Project Title: Refurbish Elevators and Replace Controls

Solicitation Questions and Answers
for
Refurbish Elevators and Replace Controls
Project: 437-22-101, RFP: 36C26324R0021
12/15/2024

Solicitation Questions and Answers (updated 3-26-2024) for
 Refurbish Elevators and Replace Controls
 Project: 437-22-101, RFP: 36C26324R0021

3 FLOOR PLAN - ELEVATOR 12 - PIT
1/4" = 1'-0"

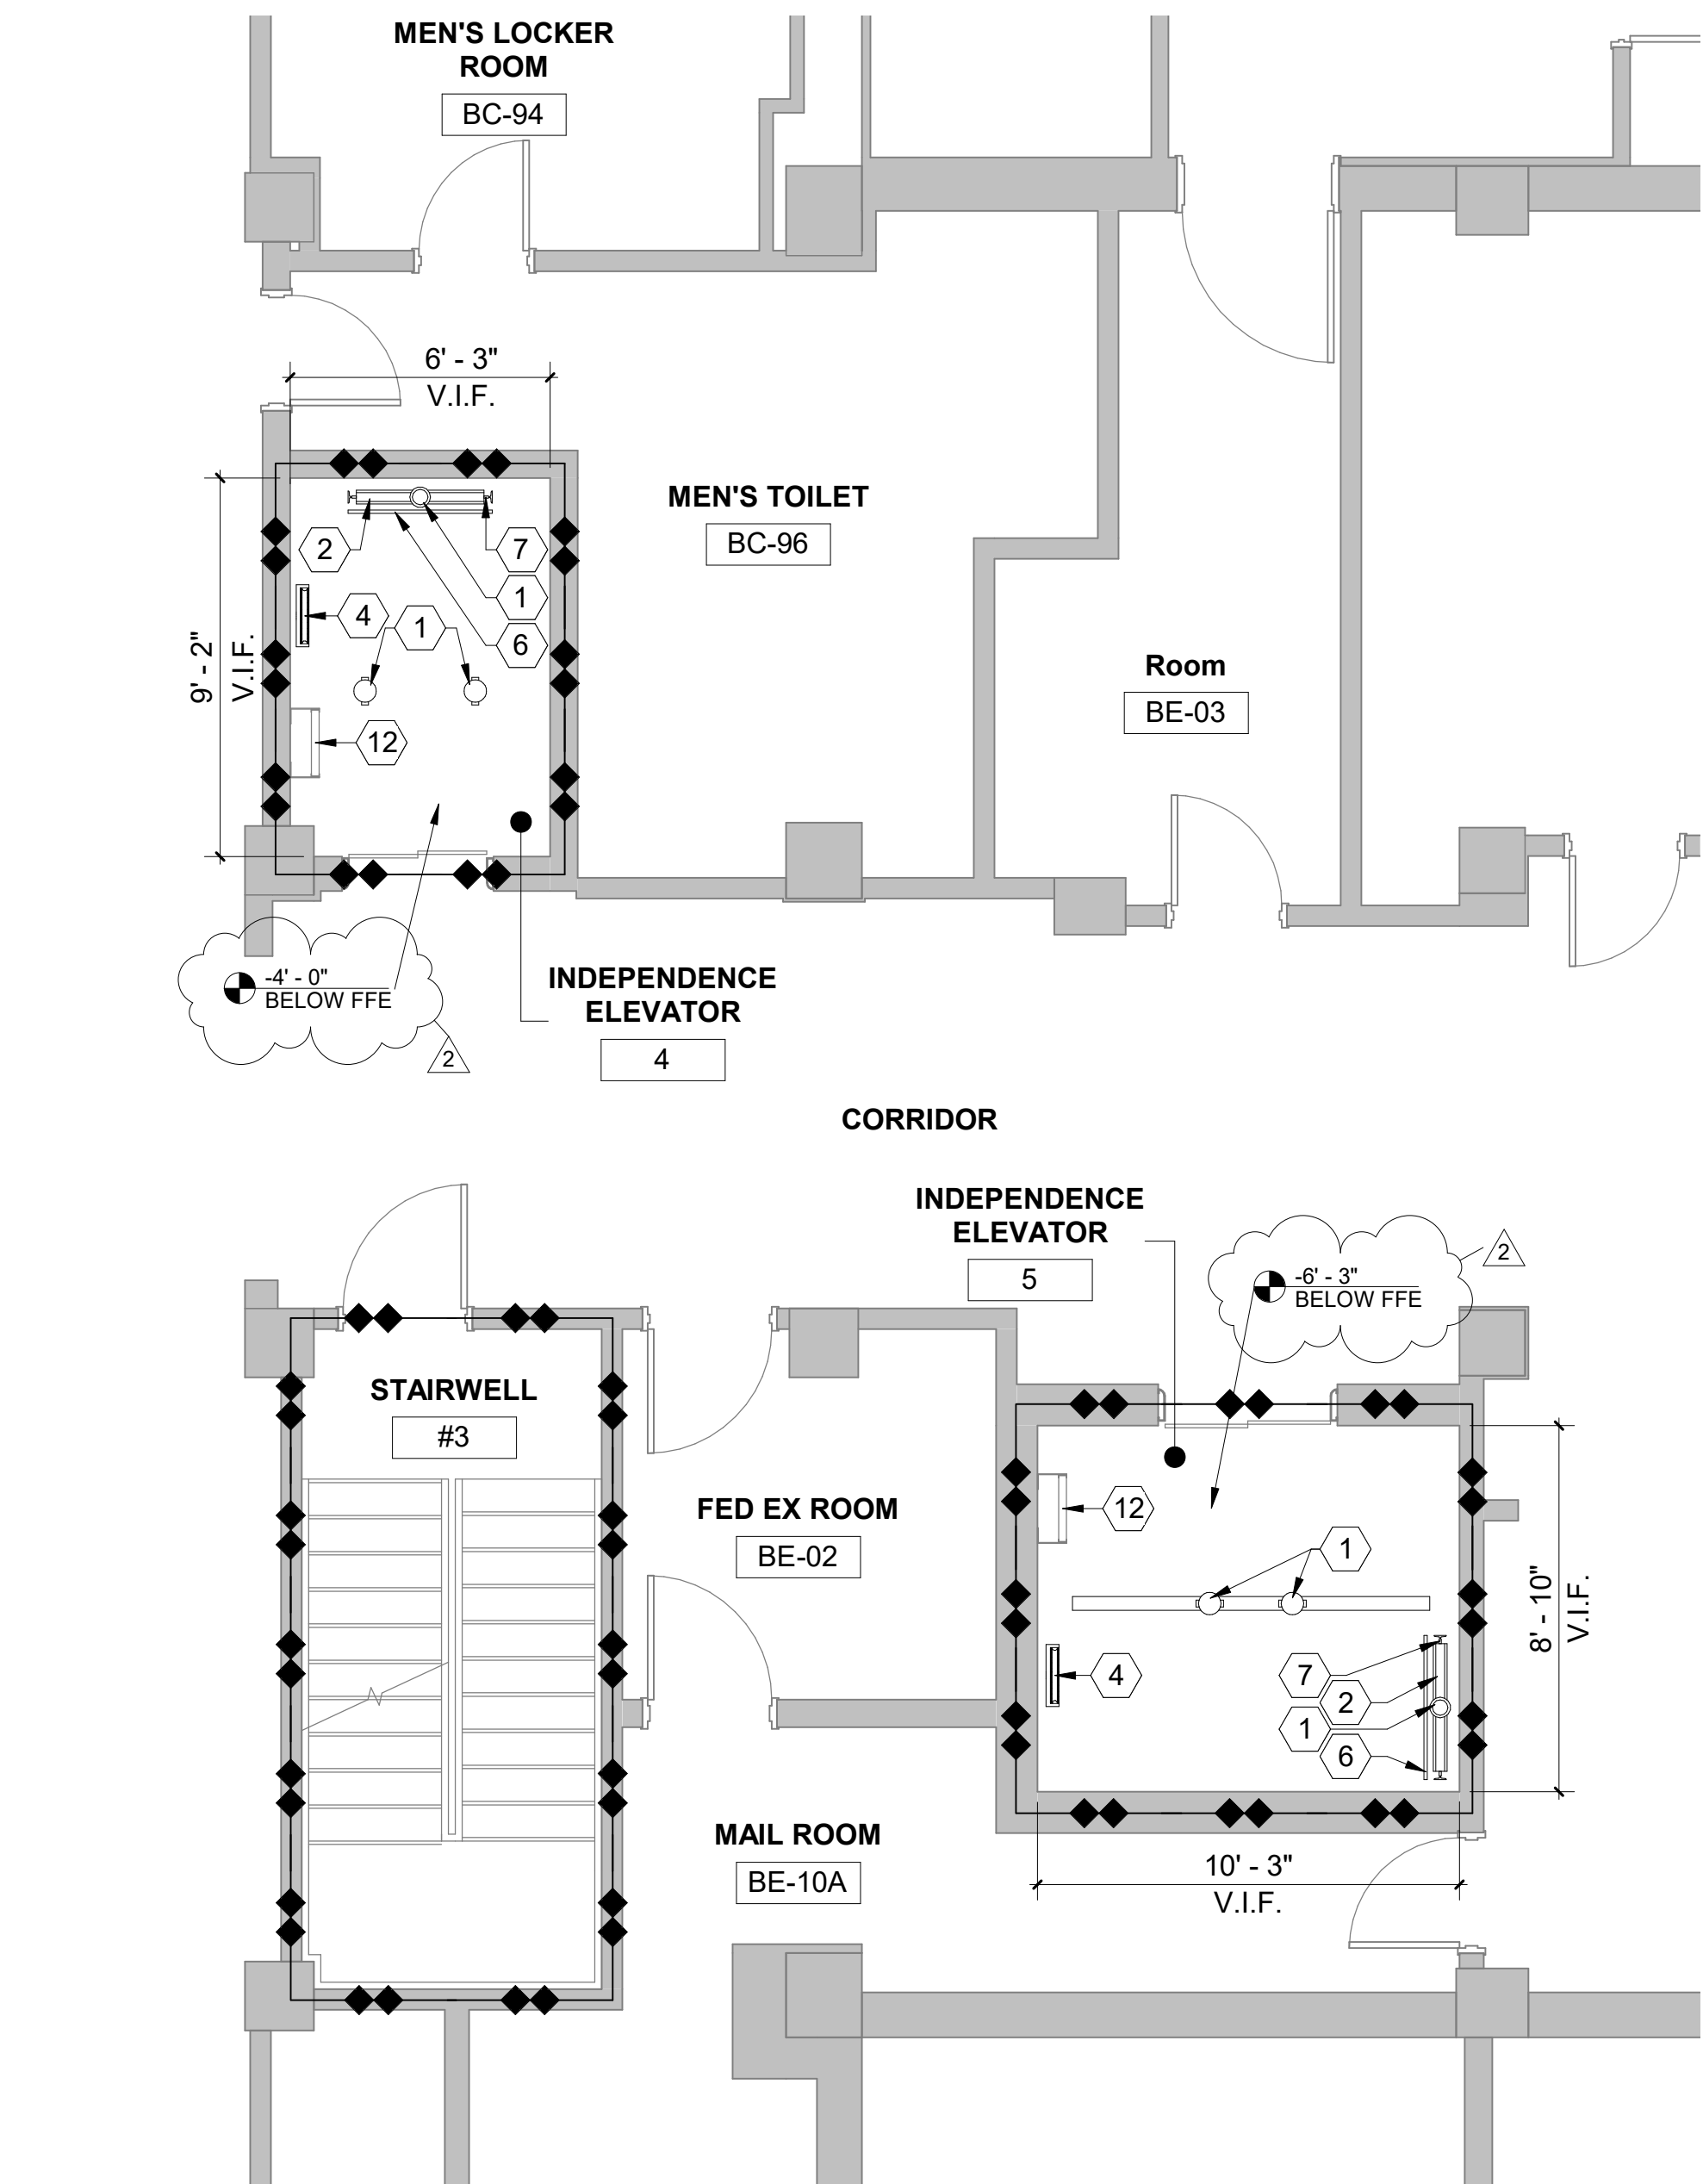
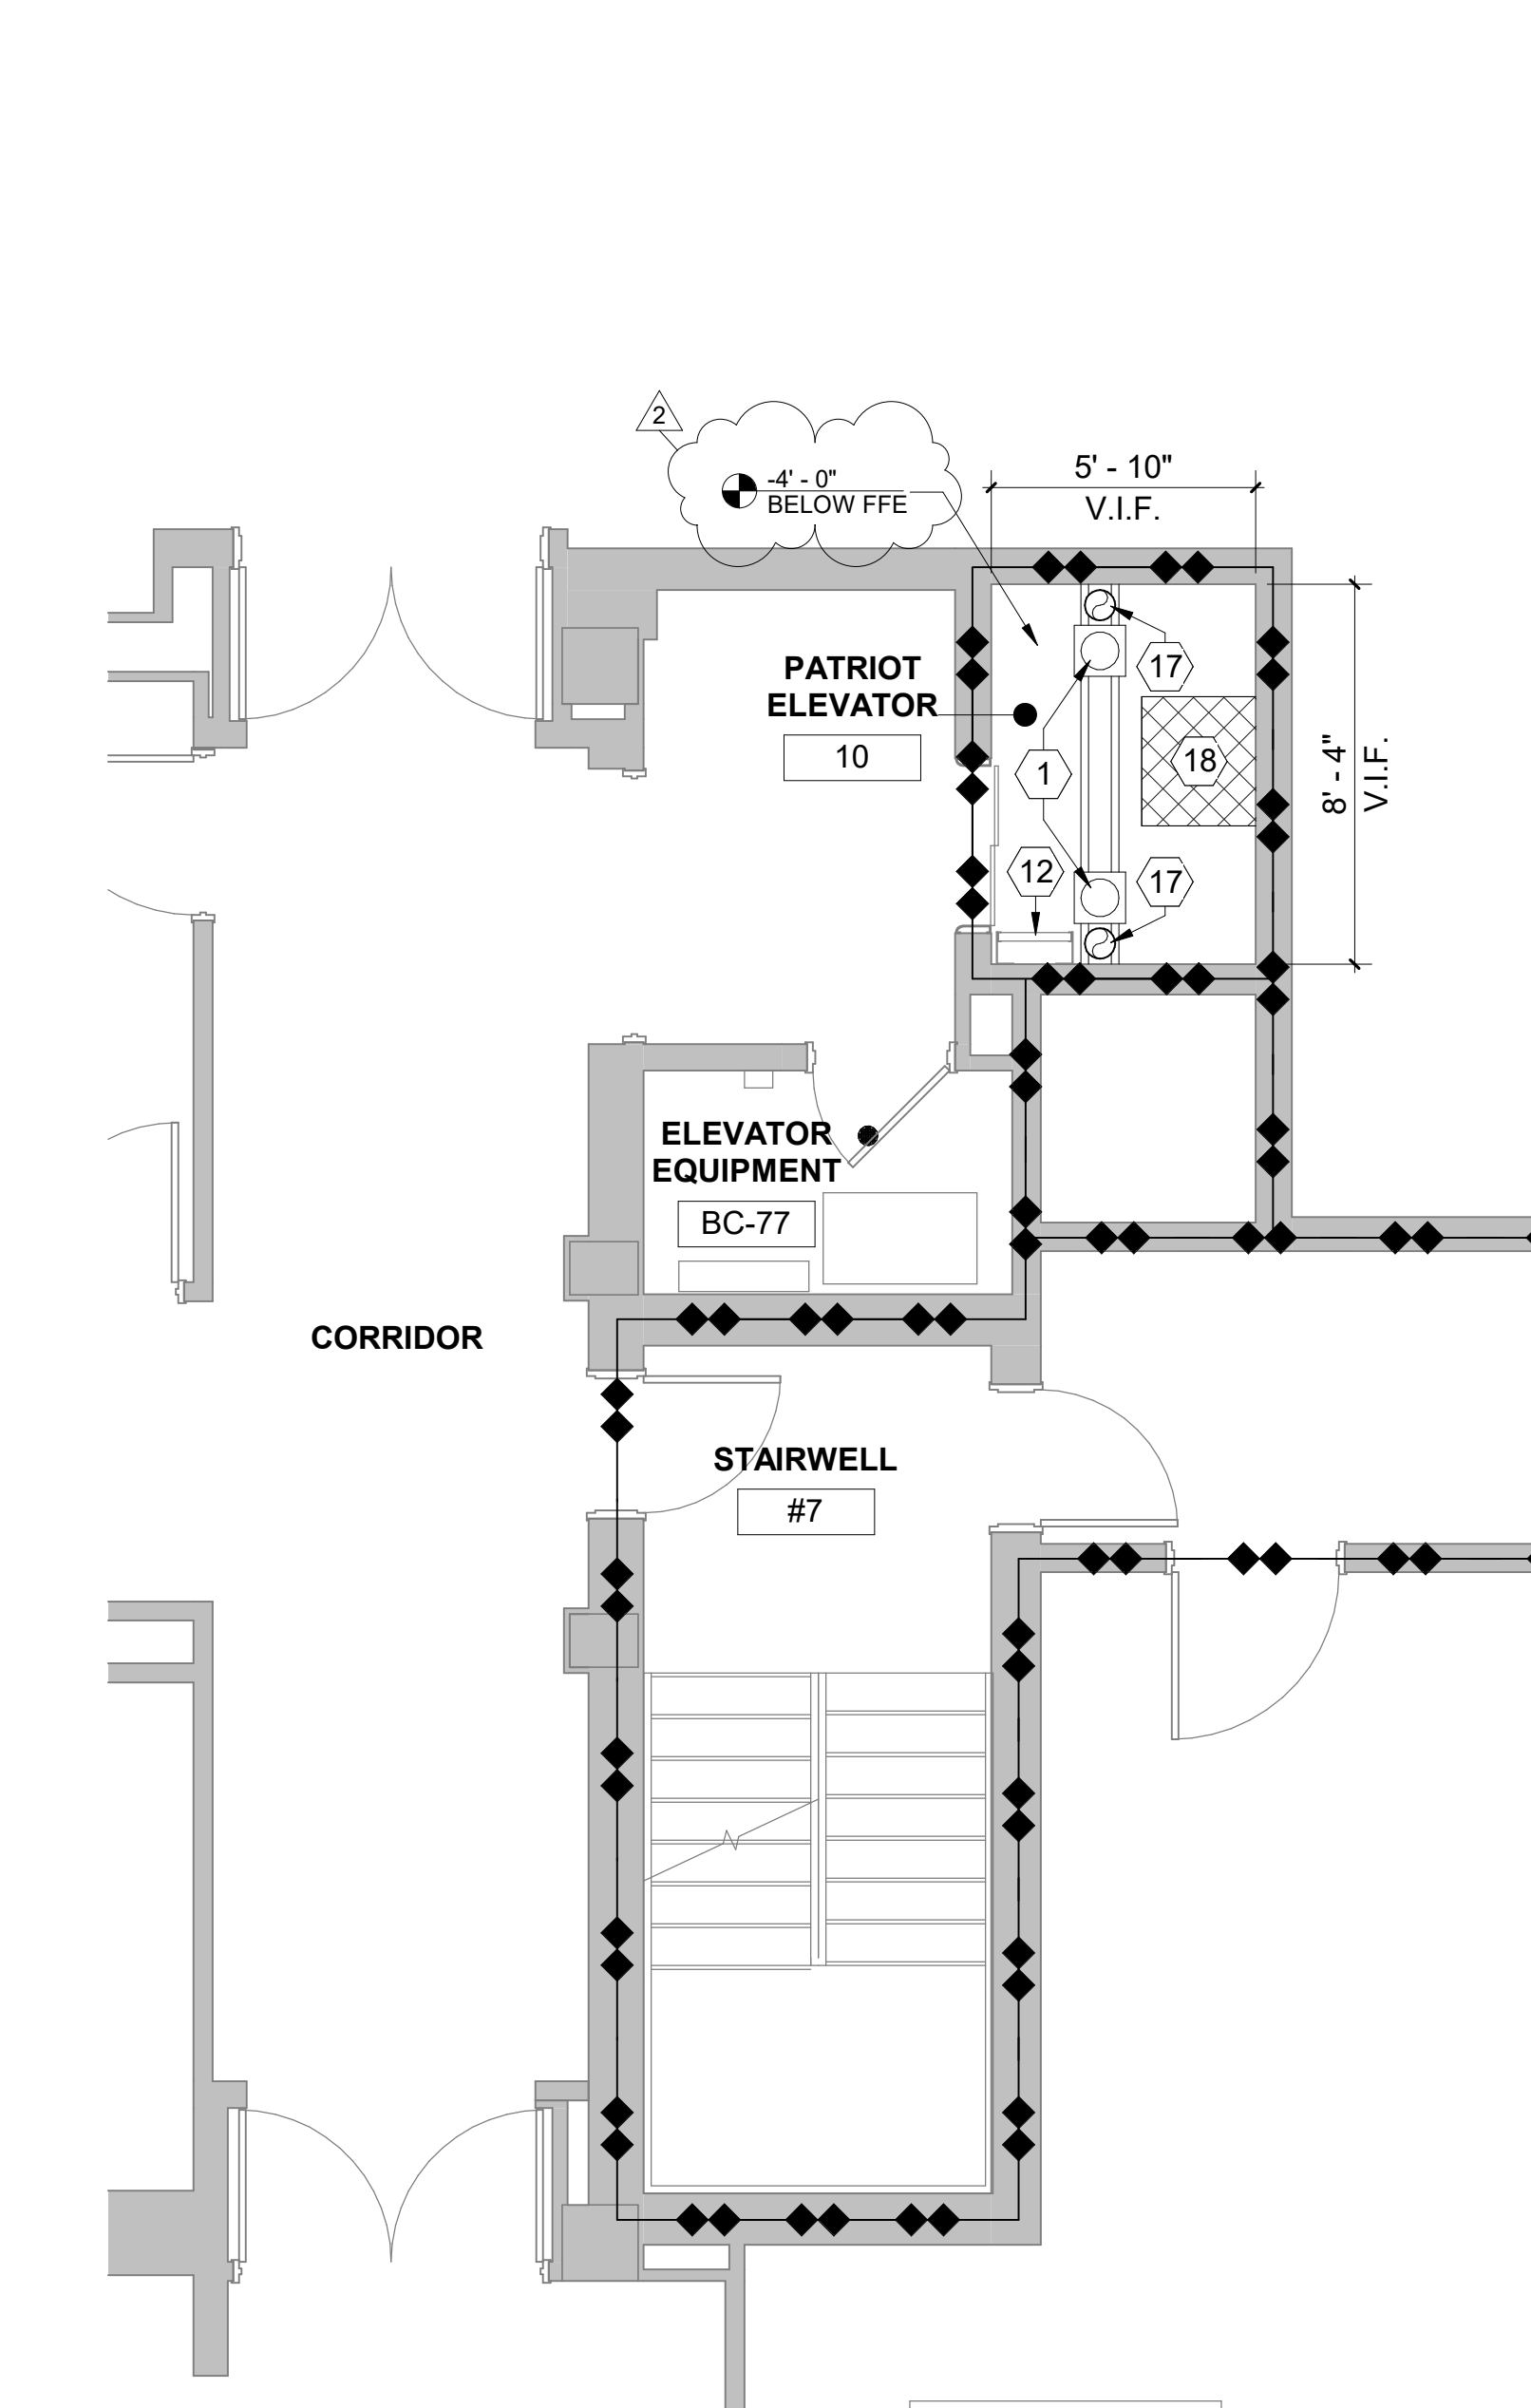
60.	2.17	2.17 - Elevator 10 does not need a casing since it is a twin post hydraulic elevator above ground. It is recommended that packing gets replaced in both jacks.	<i>Note 13/AD5.20 notes that the existing hydraulic piston is to be reused. Reuse existing hydraulic piston but replace packing in both jacks. See revised note 13/AD5.20 AND 17/A5.20.</i>

Drawing Sheet A5.20 ENLARGED PLANS – ELEVATOR PITS – See revised drawing sheet for the adjustment of keynotes # 3, 9, 15, 16, 17. Also included is the depth of each elevator pit relative to the floor elevation at the lowest elevator lobby for each hoistway.
